**SHEARON HARRIS NUCLEAR POWER PLANT, UNITS 2 AND 3
DOCKET NOS. 52-022 AND 52-023
SUPPLEMENT 2 TO RESPONSE TO REQUEST FOR ADDITIONAL INFORMATION LETTER
NO. 009 RELATED TO PROBABLE MAXIMUM FLOOD ON STREAMS AND RIVERS**

**Shearon Harris Nuclear Power Plant Units 2 and 3
Supplement 2 to Response to NRC Request for Additional Information Letter No. 009
Related to SRP Section 02.04.03 for the Combined License Application,
Dated September 17, 2008**

NRC RAI NUMBER: 02.04.03-1

NRC RAI NUMBER: 02.04.03-3

Figure 1 (FSAR Figure 2.4.3-201): Study Area

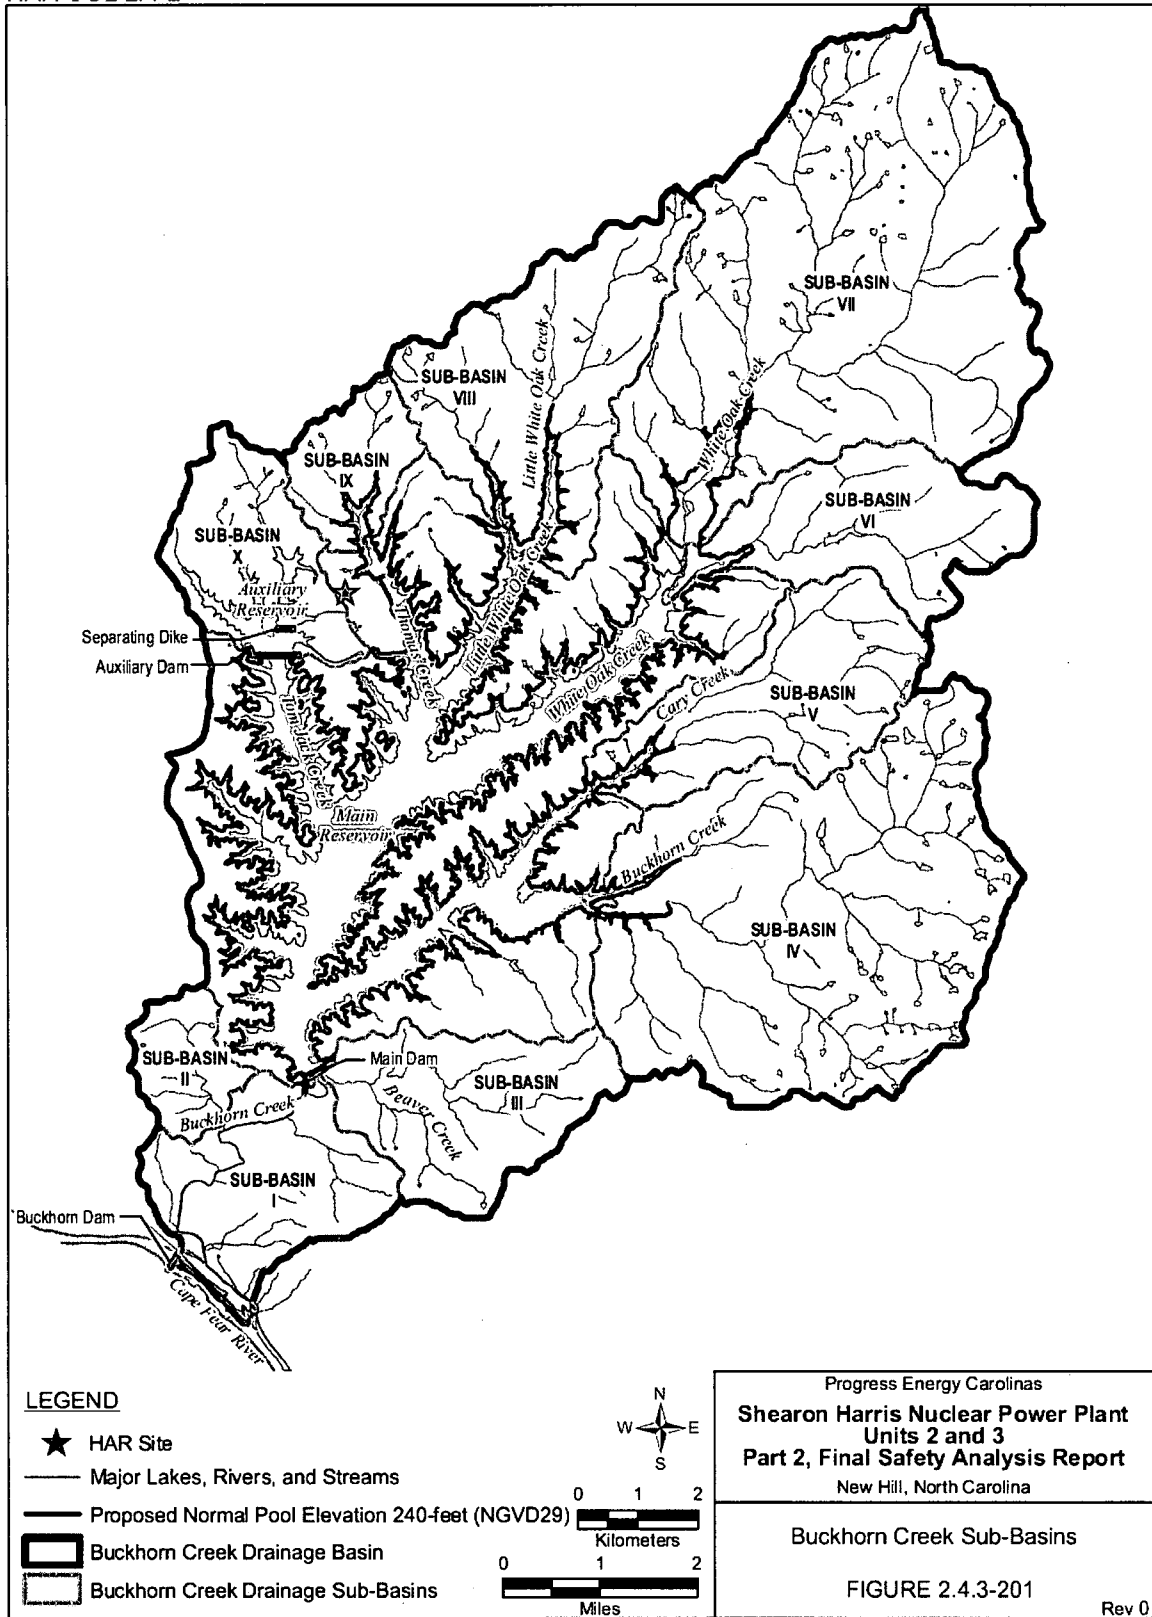
The applicant derived longest flow path for the residual subbasin extends beyond the subbasin and terminates at the spillway of the Main dam, producing a longer lag time than if the flow path terminated at the edge of the residual subbasin. Staff request that the applicant describe how the increased lag time from this approach results in a conservative PMF estimate.

To apply the unit hydrograph approach to the Buckhorn Creek Drainage Basin, unit hydrographs were developed for all the sub-basins above the Main Dam, excluding the reservoir pool areas. **Figure 1** (FSAR Figure 2.4.3-201) shows Buckhorn Creek Drainage sub-basin areas above the Main Dam. This figure illustrates that Sub-basins I, II, and III fall below the Main Dam spillway. Therefore, these sub-basins were not considered in the drainage area at the Main Dam. Excluding these sub-basins, the total drainage area at the Main Dam is 182.1 square kilometers (km^2) (70.3 square miles [mi^2]). This area also includes the drainage area at the Auxiliary Reservoir. **Table 1** (FSAR Table 2.4.3-218) lists the areas of the Auxiliary Reservoir Surface, Main Reservoir Surface, Residual Land Surface, and Sub-basins IV, V, VI, VII, VIII, IX, and X.

Alternate conservative parameters for the residual area were used in order to reduce the lag time from 10.6 to 2.0 hours. This change has increased the peak flow from the residual area from 796 cfs to 4311 cfs. These additional conservative steps were performed to address the NRC's concern with lag time based on Snyder's unit hydrograph equations and geometrical characteristics associated with the land area surrounding the Main Reservoir.

Figure 1: 1-Hour Base Unit Hydrographs from FSAR

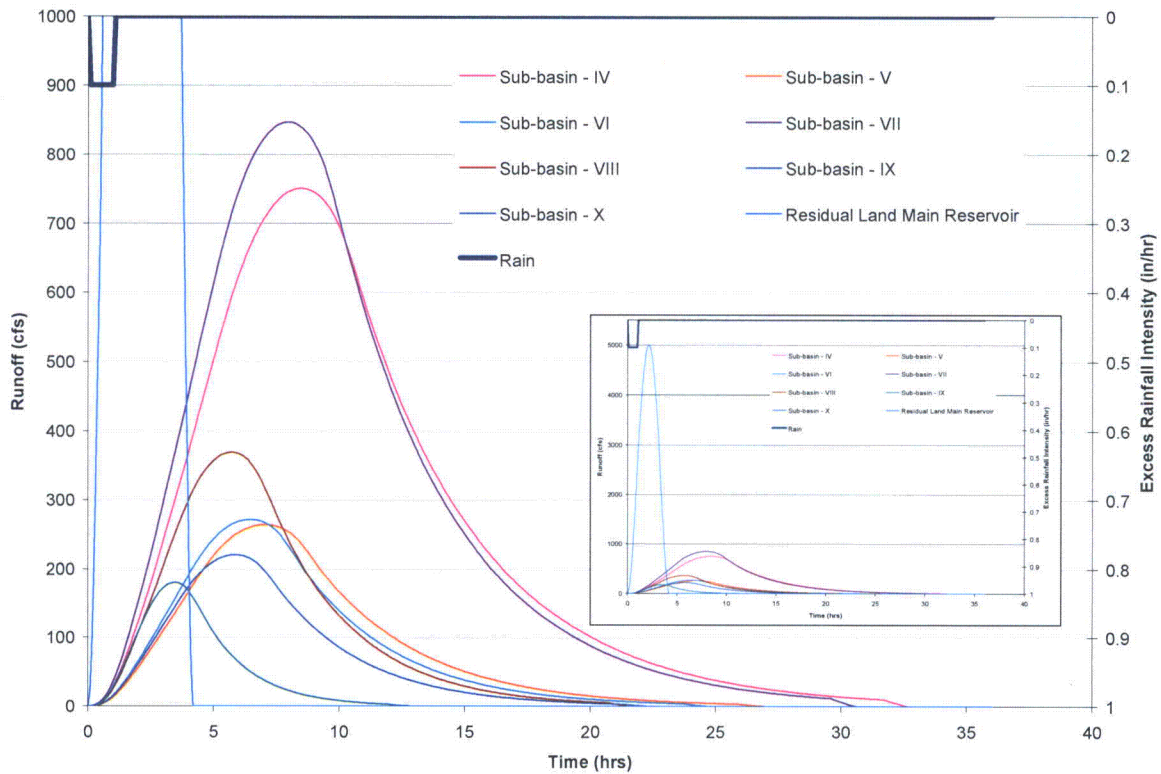
Please describe how a peaking coefficient of 0.75 results in a conservative PMF estimate.

In order to represent the PMF conditions according to the recommendation of *ER 1110-8-2(FR)* (USACE, *Engineering and Design, Inflow Design Floods for Dams and Reservoirs, Engineer Regulation 1110-8-2(FR)*, USACE, Washington, D.C., 1991), the 1-hour base unit hydrographs developed for the FSAR analysis using the Snyder method were peaked by 25 percent. That is, the unit hydrographs (**Figure 1**) were adjusted such that the peak flows were increased by 25 percent, while the unit volume of each unit hydrograph was maintained. Given these adjustments, the appropriate time base and lag times of the peaked unit hydrographs were determined. The revised parameters associated with the peaked unit hydrographs are provided in **Table 2**. (Refer to **FSAR Table 2.4.3-219** for the 1-hour base unit hydrograph parameters.)
